ADDENDUM# 3

**University of Kentucky
2555.0 Delta Gamma House New Construction**

Addendum #03

Written Questions and Answers

DWG. NO.
LH201

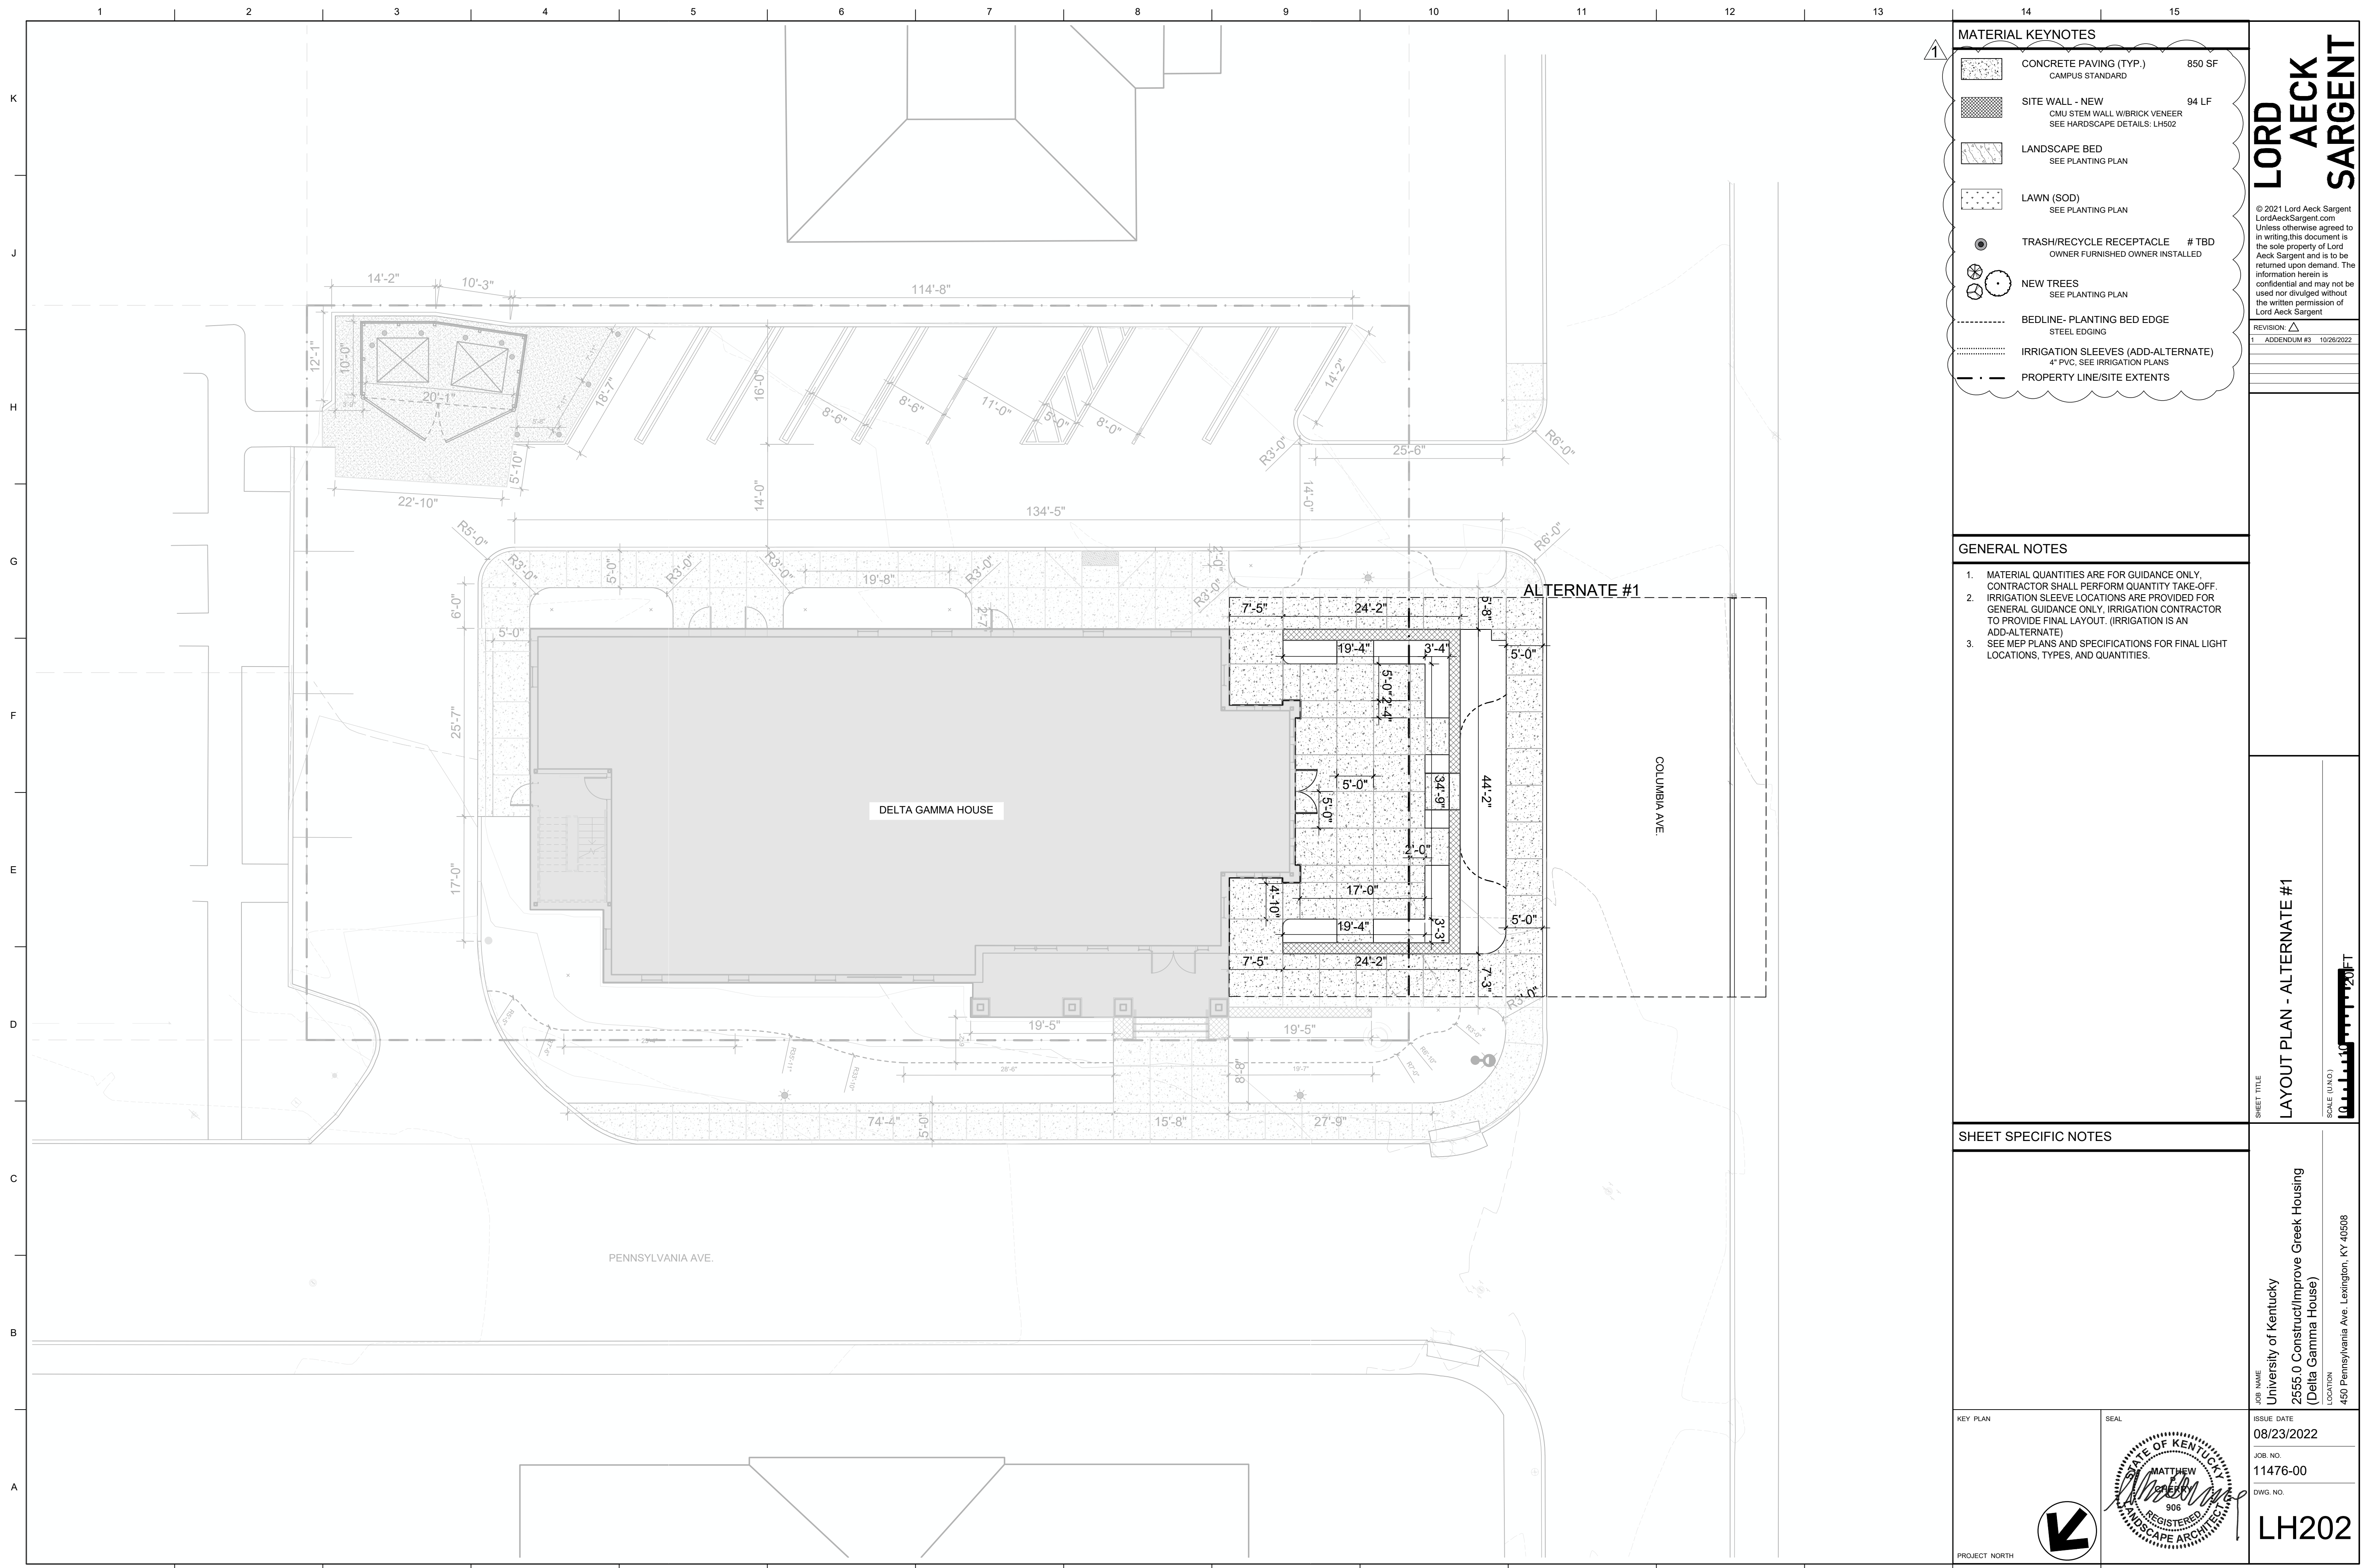
LH102	SITE PLAN – ALTERNATE #1	10/26/22
	<ul style="list-style-type: none">• Material update to remove pavers.	
LH201	LAYOUT PLAN	10/26/22
	<ul style="list-style-type: none">• Material update to remove pavers.	
LH202	LAYOUT PLAN – ALTERNATE #1	10/26/22
	<ul style="list-style-type: none">• Material update to remove pavers.	
P001	UNDERFLOOR PLUMBING PLAN	10/26/22
	<ul style="list-style-type: none">• Add mop basin in Dry Storage Rm 134A per Jurisdiction Review	
P101	SANITARY WASTE AND VENT PLUMBING PLAN – LEVEL 01	10/26/22
	<ul style="list-style-type: none">• Add mop basin in Dry Storage Rm 134A per Jurisdiction Review	
P201	DOMESTIC WATER PLUMBING PLAN – LEVEL 01	10/26/22
	<ul style="list-style-type: none">• Add mop basin in Dry Storage Rm 134A per Jurisdiction Review	
P400	PLUMBING RISERS	10/26/22
	<ul style="list-style-type: none">• Add mop basin in Dry Storage Rm 134A per Jurisdiction Review	
P402	PLUMBING RISERS	10/26/22

ISSUE DATE
09/30/2022
JOB NO.
11476-00
DWG. NO.
P001

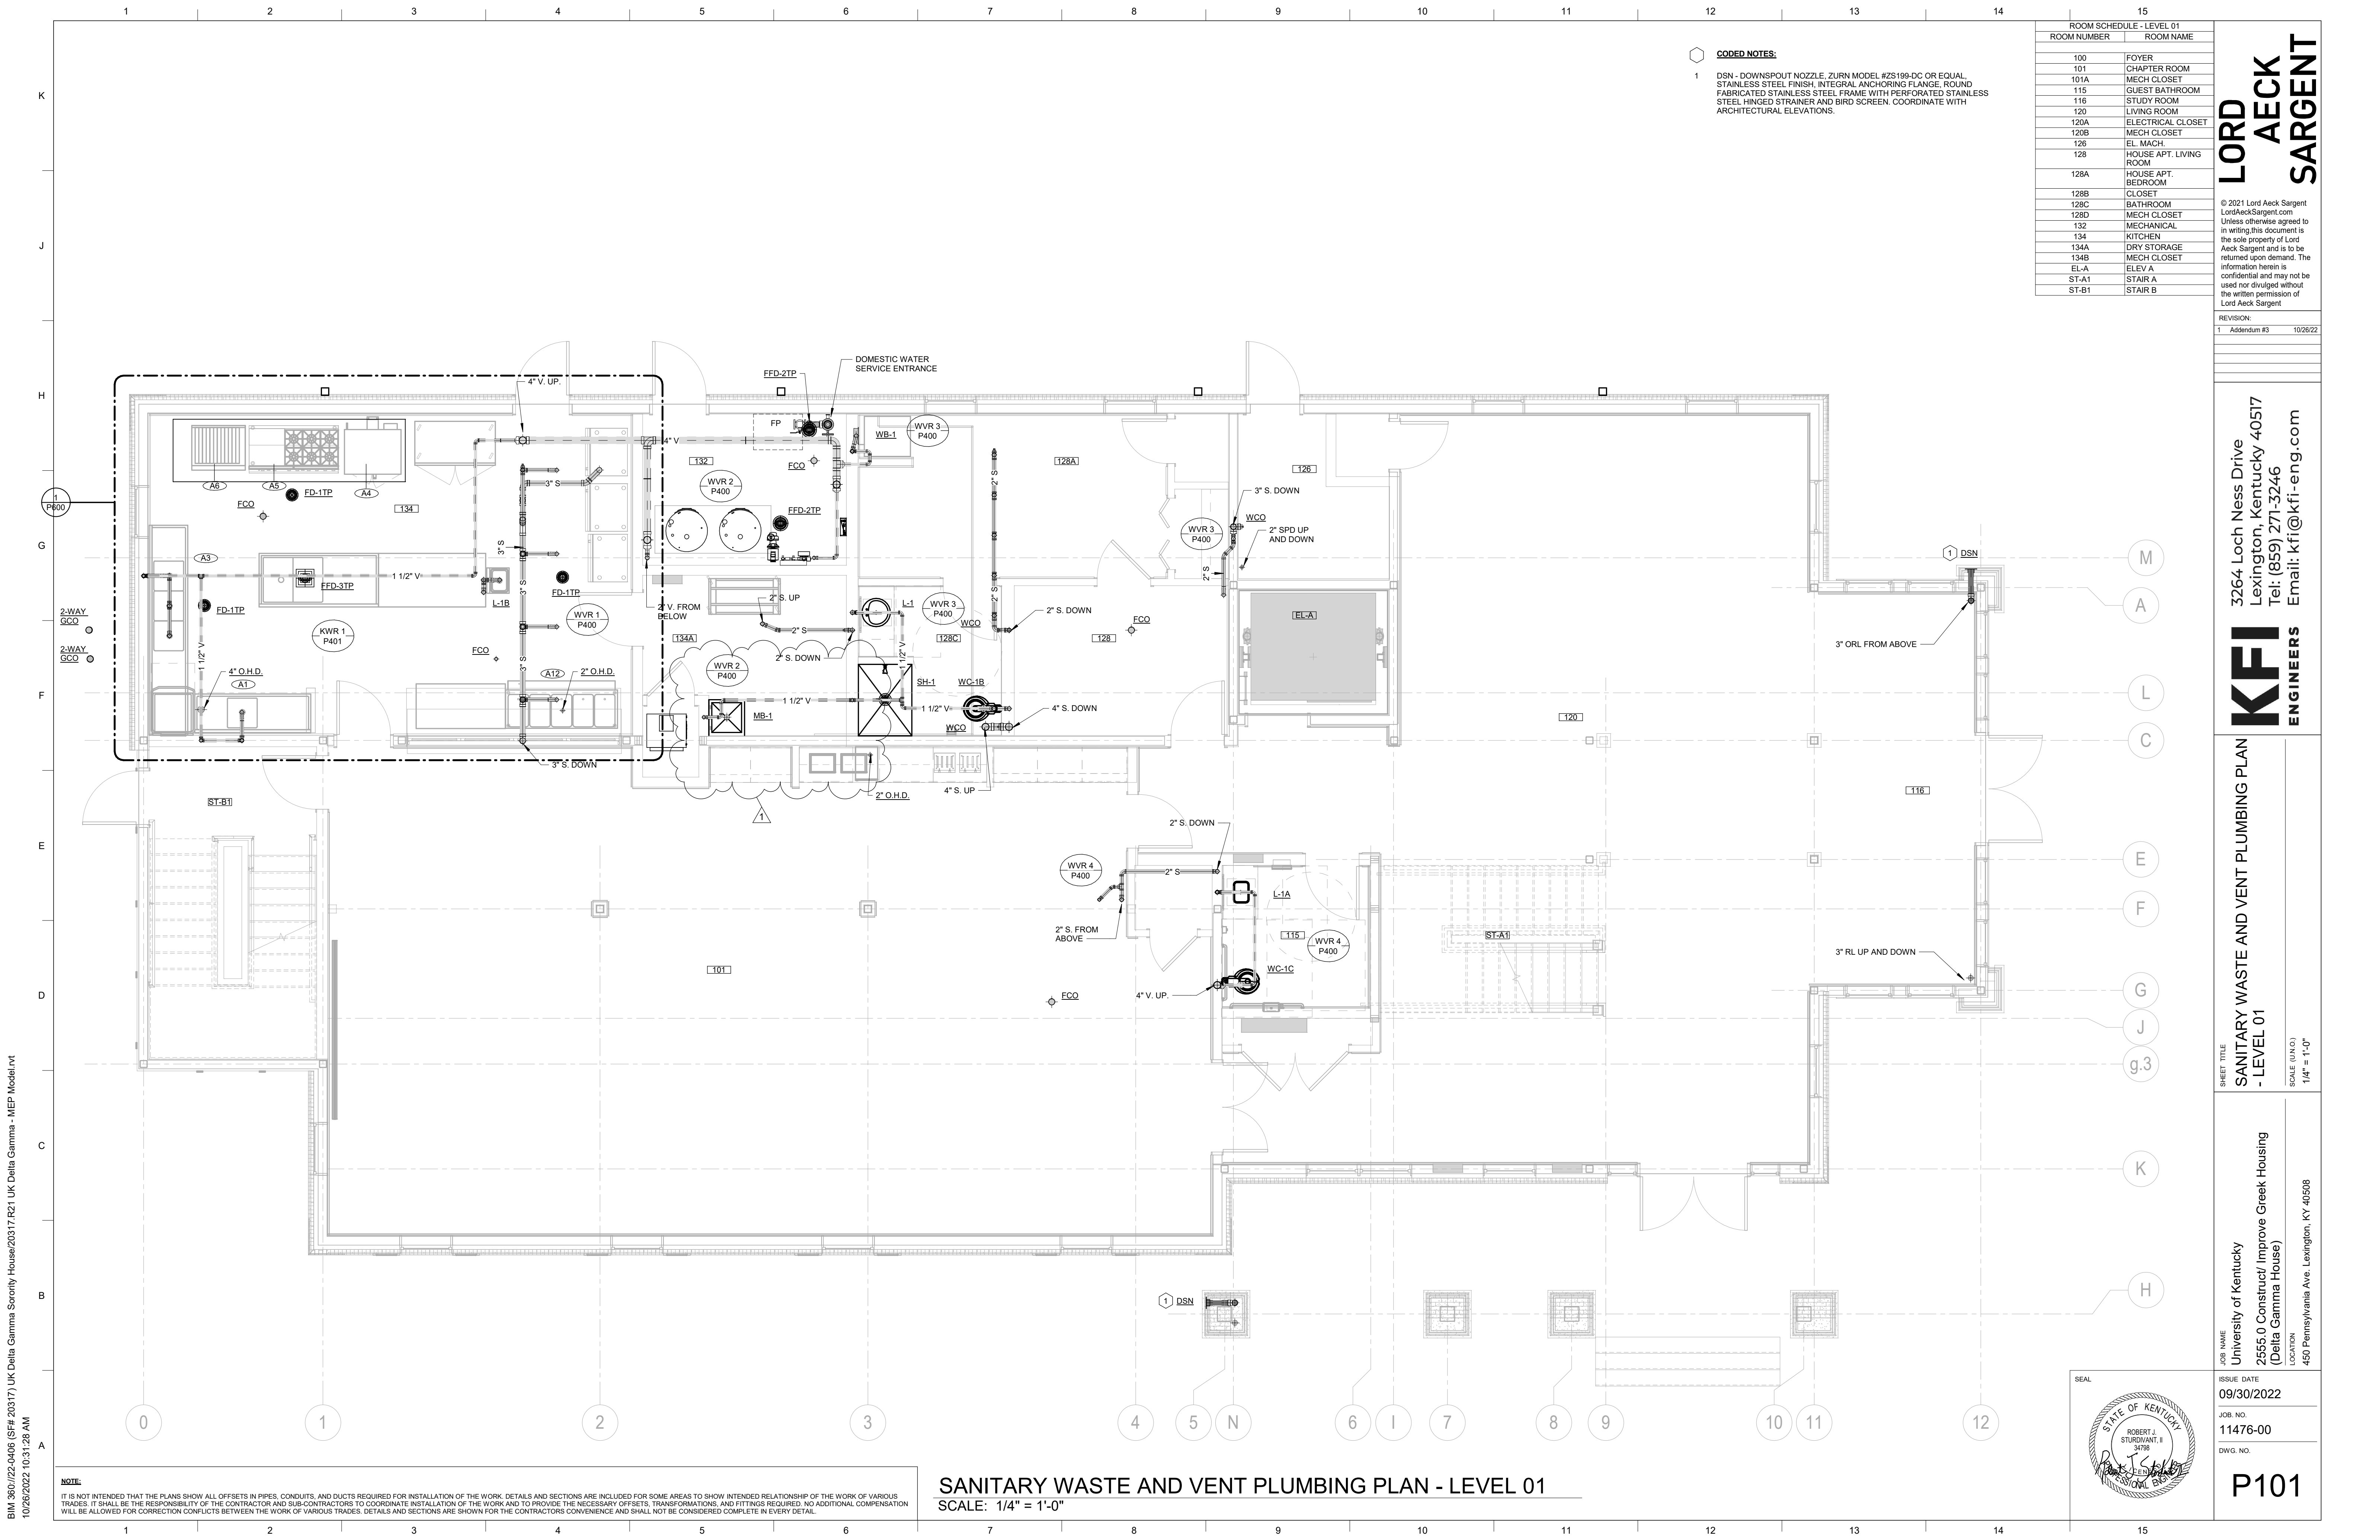
No.	Question	Firm	Answer
1.	Drawing P001 says see civil drawing for storm please advise drawing number.	KFI/ Prime AE	See CE2 tag 13, storm to tie to existing system.
